UNITED STATES PATENT AND TRADEMARK OFFICE

| APPLICATION NO. | FILING DATE | FIRST NAMED INVENTOR | ATTORNEY DOCKET NO. | CONFIRMATION NO. |
|---|-------------|----------------------|----------------------------------|------------------------|
| 10/816,371 | 04/01/2004 | Christoph Becke | 2001P14042WOUS | 9654 |

| Office Action Summary | Application No. | | Applicant(s) | |

Attachment A

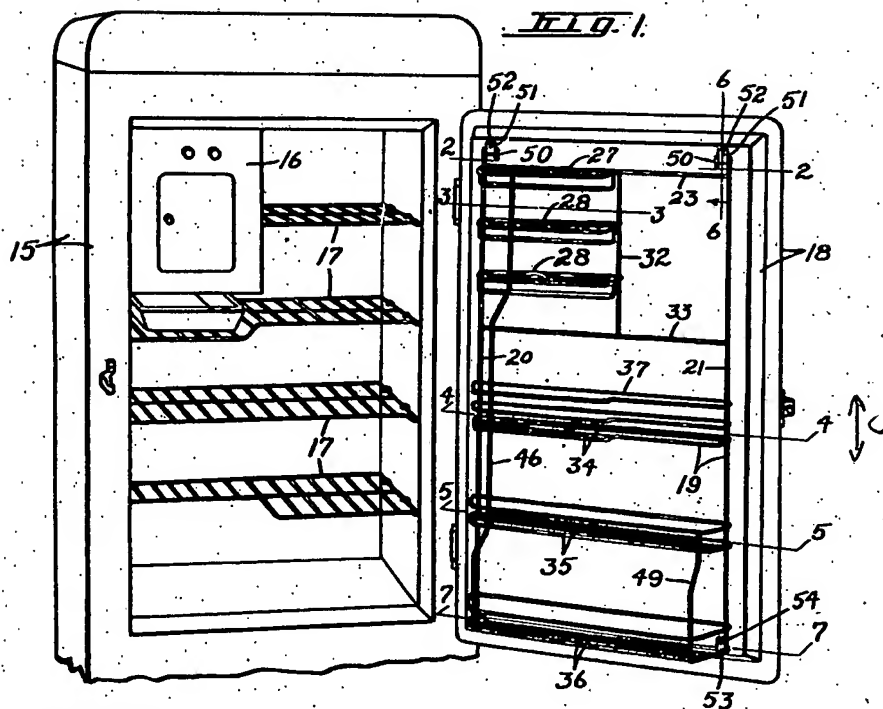
Claims 9, 10, 12, and 13 are rejected under 35 U.S.C. 102(b) as being anticipated by Gentz (2,074,785). Gentz teaches a refrigerator having a door with door storage compartment (Fig. 1; see Attachment A) comprising: at least one first generally boxed storage compartment portion (a) having a full first horizontally-directed depth (b) and a first vertically-directed storage depth (c); and at least one second generally boxed shaped storage compartment portion (d) having a front wall (front bars), the second storage compartment portion having a second horizontally- directed depth (e) being less than the full first horizontally-directed depth and following the first storage compartment portion in a longitudinal direction of the door storage compartment, and the front wall of the second storage compartment portion having a second vertically-directed storage depth substantially the same as the first vertically-directed storage depth (c), whereby the second vertically-directed storage depth of the second storage compartment portion is substantially the same as the first vertically directed storage depth. The compartment portions are separated by an intermediate wall (39).

Claims 11 and 16 are rejected under 35 U.S.C. 103(a) as being unpatentable over Gentz. As stated above, Gentz teaches the limitations of claim 9, including two portions of a compartment with substantially equal lengths, the portions having different depths. For claim 11, Gentz fails to teach that the portions have different lengths. However, it would have been an obvious design consideration to one having ordinary skill in the art to dimension the portions as desired, including forming them with different lengths, depending on the desired need of the person designing/constructing the compartment (and/or refrigerator), e.g. depending on intended storage uses, for aesthetic reasons, etc.

For claim 16, Gentz fails to teach that the second depth is less than half the first depth. However, it would have been an obvious design consideration to one having ordinary skill in the art to dimension the second section as desired, including forming its compartment with a smaller depth, depending on the desired need of the person designing/constructing the section (and/or refrigerator), e.g. depending on intended storage uses, for aesthetic reasons, etc.
